<b>PART - GROUP CHANGE NOTIFICATION</b>				Bulletin no	2002-01	Date	10.06.2002	
	Prepared by	Hakan Amaç-Yaşar Ceylan				Signature			
	Approved by								
	Copy to	TH-YPLB	✓	ÇMİ-MTK1	✓	ÇMİ-ÜPB		Other .....	
		ÇMİ-KGB	✓	ÇMİ-MTK2	✓	ÇMİ-MÜT		Other .....

**Issue** Water Diverting System Change

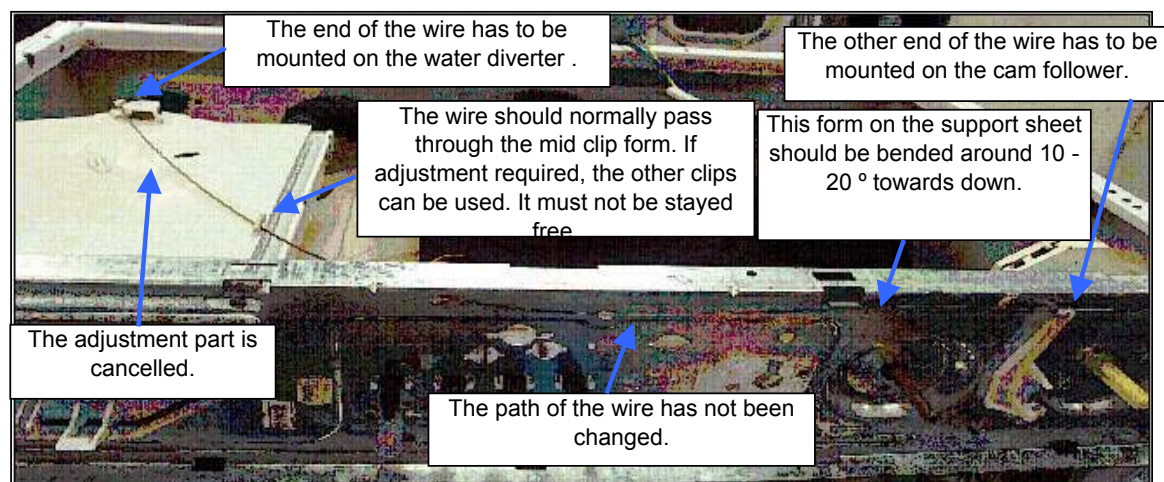
This modification should be used in case of persistent water diverting problems. Before the service activity, possible wrong usage by consumer, adjustment defects, position of the movement transmission wire assembly and the form of the cam follower should be checked. 2801000100 stock numbered old movement transmission wire has been replaced by the new 28090100100 stock numbered movement transmission wire. If either of detergent box or movement transmission wire have to be replaced in any case of water diverting failure, the other part has to be replaced free of charge.

#### How to mount new movement transmission wire:

The path of the new wire is the same as the older one.

The wire has to be fixed at the middle clip on the detergent box cover.

If there is a failure of water diverting, wire has to be fixed to the other clip. Choosing which clip is appropriate depends on the tightness of the wire. The wire must not be fixed out of any clips.

In any case, if one of the clips is broken, detergent box has to be replaced.
